DESCRIPTIVE REPORT

Type of Survey ... Navigable Area Hydrographic...
Field No. DA-10-4-81
Office No..... H-9977.....

State Alaska
General Locality Chatham Strait
Locality Rowan Bay

DESCRIPTIVE REPORT
ROWAN BAY, ALASKA
H-9977 OPR-0353-DA-81

CHART 17370
SCALE 1:20,000

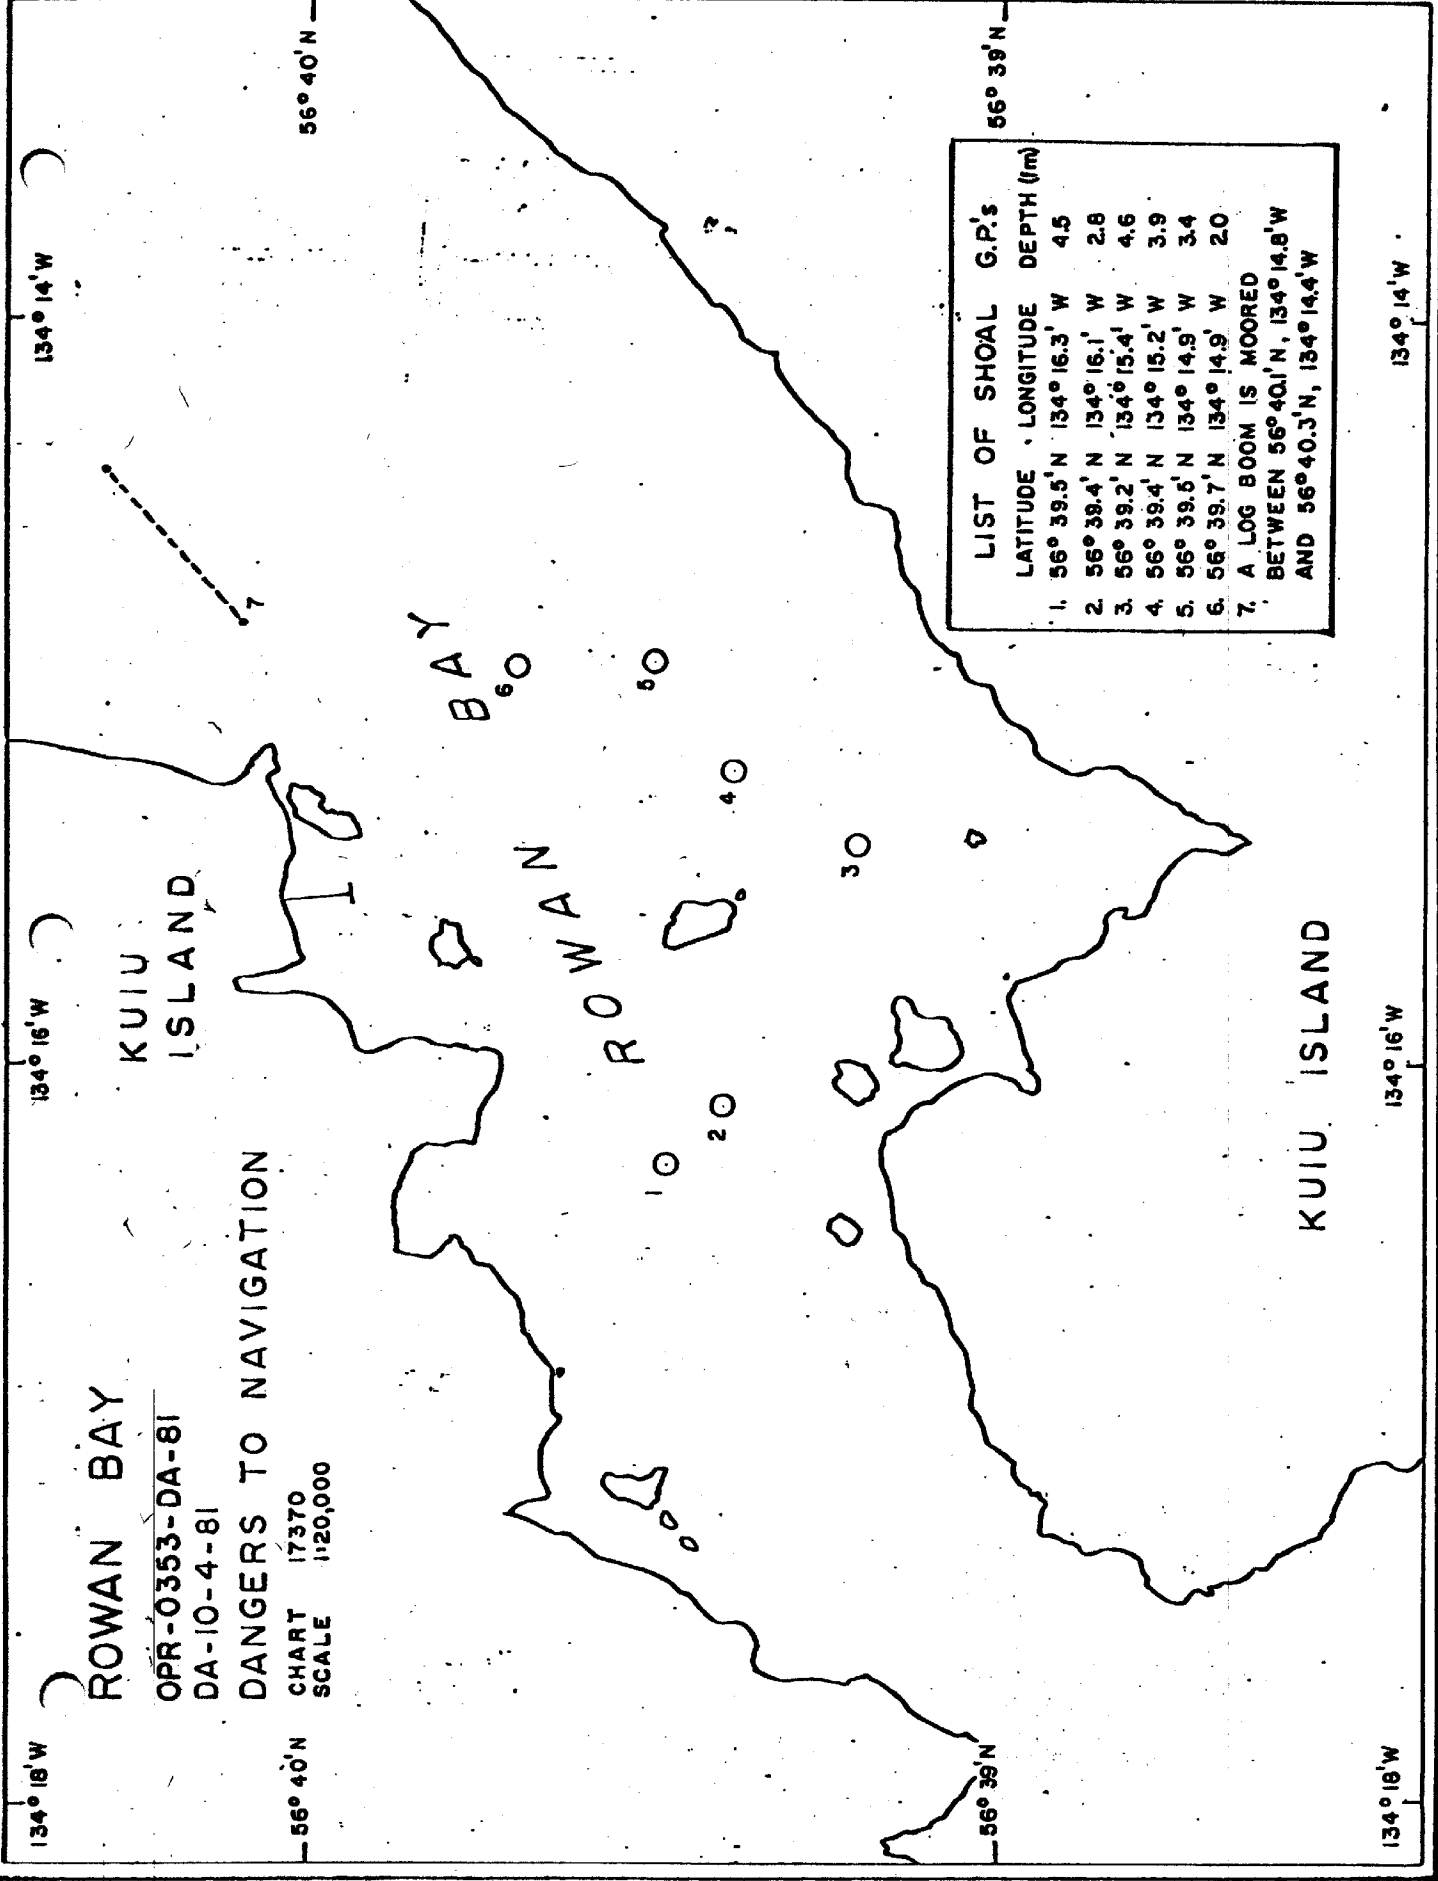
LIST OF SHOAL G.P.'s		
LATITUDE	LONGITUDE	DEPTH (m)
1. 56° 39.5' N	134° 16.3' W	4.5
2. 56° 39.4' N	134° 16.1' W	2.8
3. 56° 39.2' N	134° 15.4' W	4.6
4. 56° 39.4' N	134° 15.2' W	3.9
5. 56° 39.5' N	134° 14.9' W	3.4
6. 56° 39.7' N	134° 14.9' W	2.0
7. A LOG BOOM IS MOORED BETWEEN 56° 40.1' N, 134° 14.8' W AND 56° 40.3' N, 134° 14.4' W

SUBJECT: Apparent Shoreline Discrepancies on H-9977, Rowan Bay, Alaska

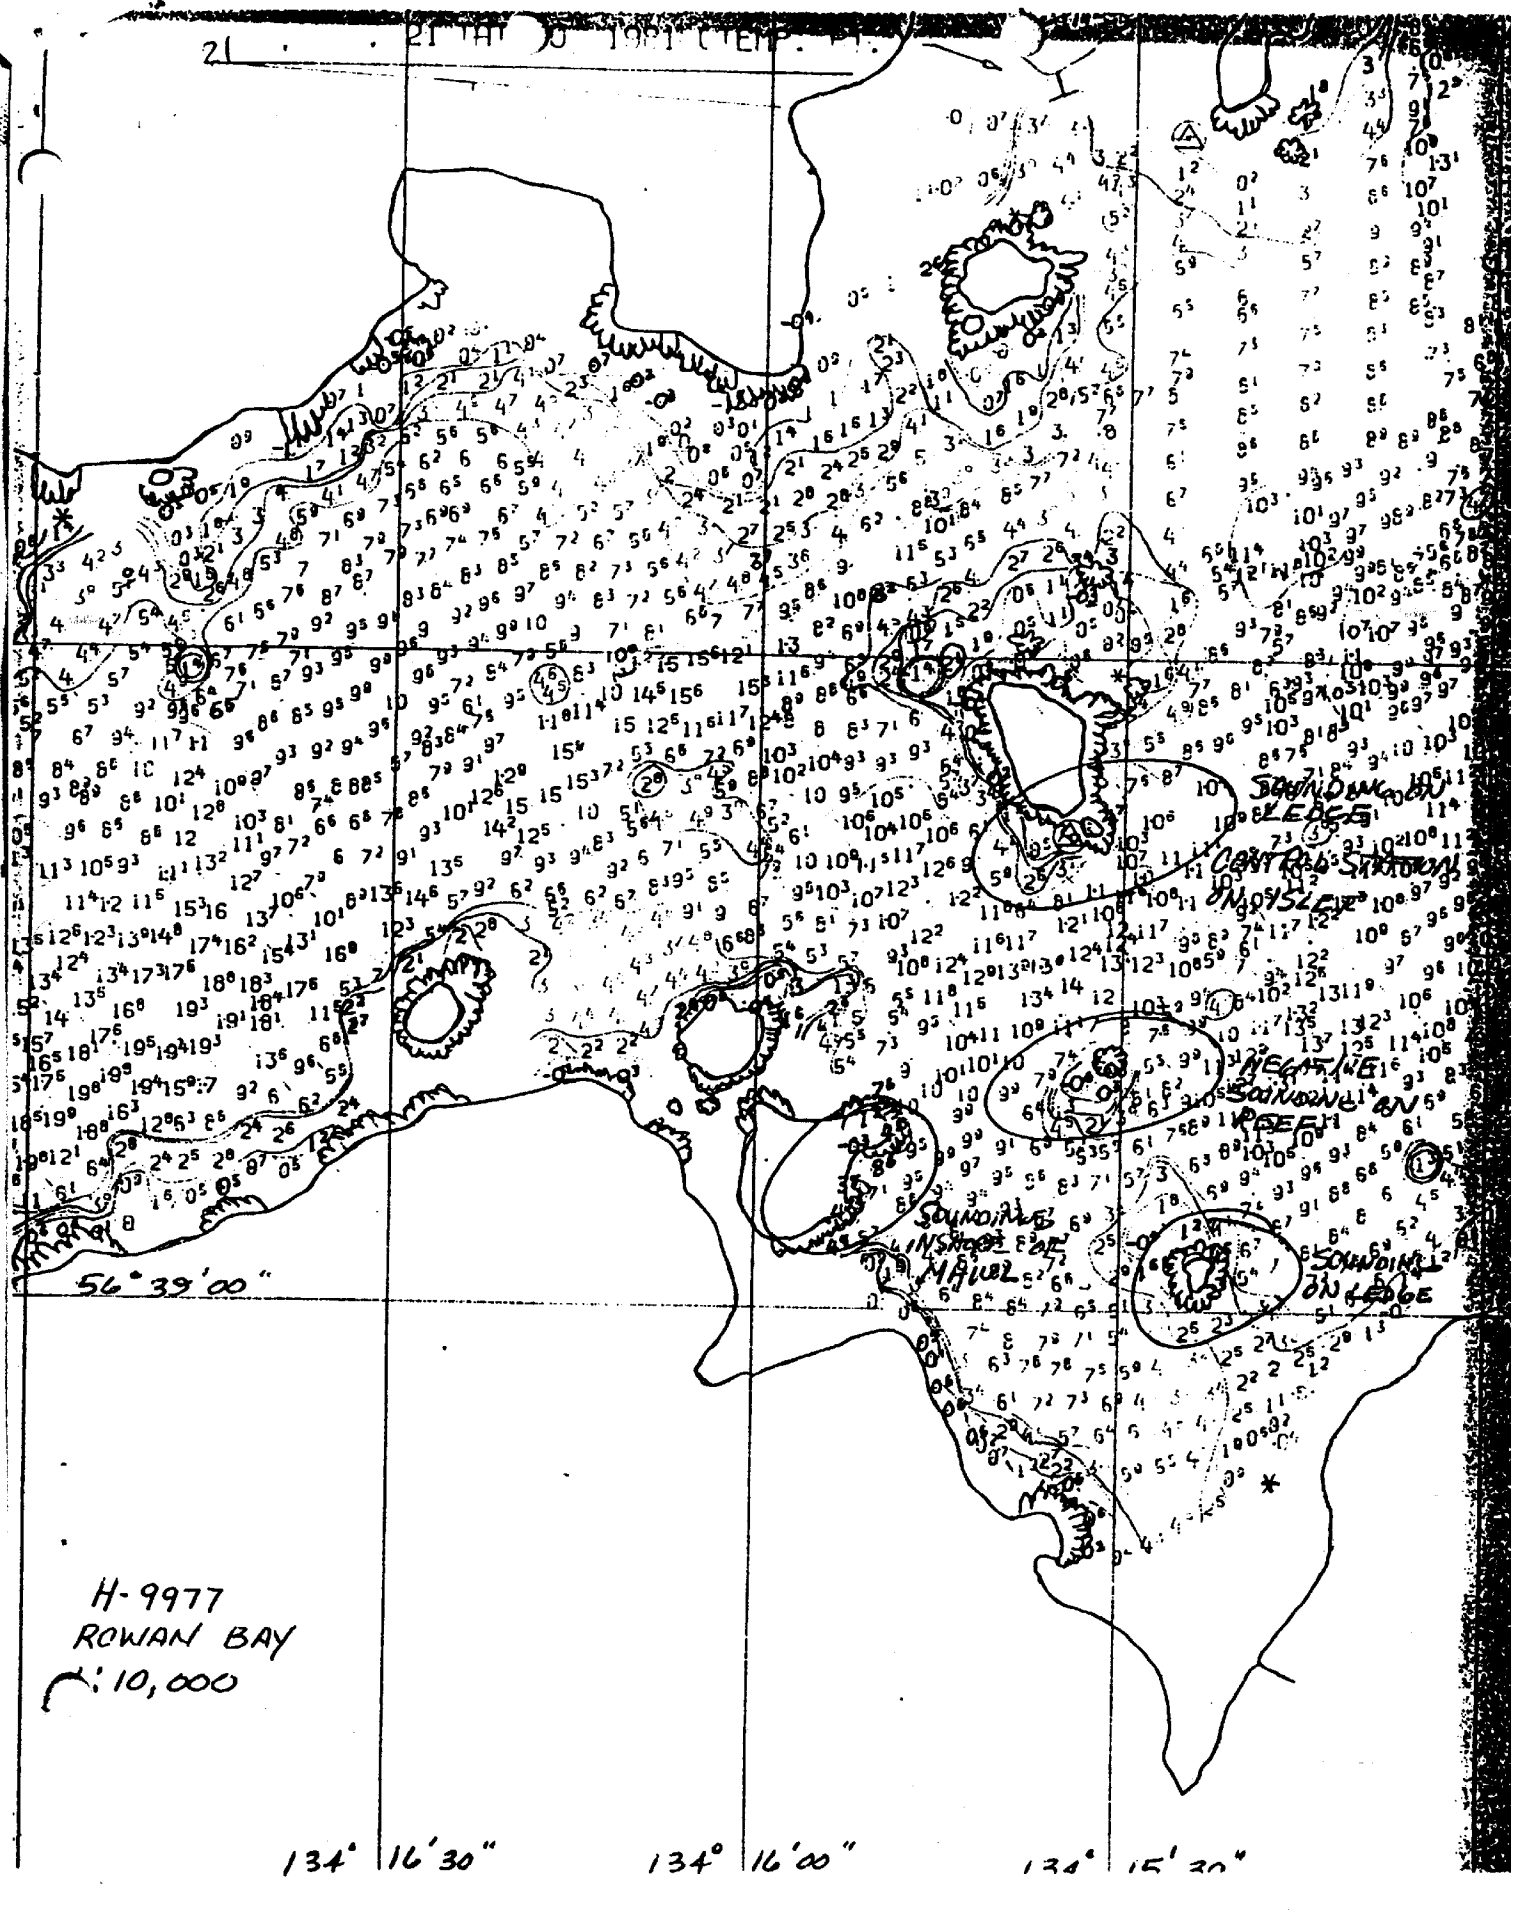
As discussed during our telecon on July 27, attached is a copy of a section of H-9977 noting some of the shoreline discrepancies between the contemporary hydrographic survey findings and the charted shoreline from NOAA Chart 17370.

The source of the charted shoreline originates with H-2334, 1:20,000 scale, 1897. It appears that an incorrect datum shift may have occurred during chart compilation, as the contemporary survey indicates a displacement of the charted shoreline in the approximate direction of 080° from north and a distance of 40 to 50 meters. Shoreline details from the Port Alexander (C-1) quadrangle, Alaska, 1:63,360 scale topographic map will be evaluated which may confirm the incorrect datum shift.

H-9977 is currently scheduled for completion during November, 1982 and, unless otherwise directed by C35, the smooth sheet will be submitted without shoreline.
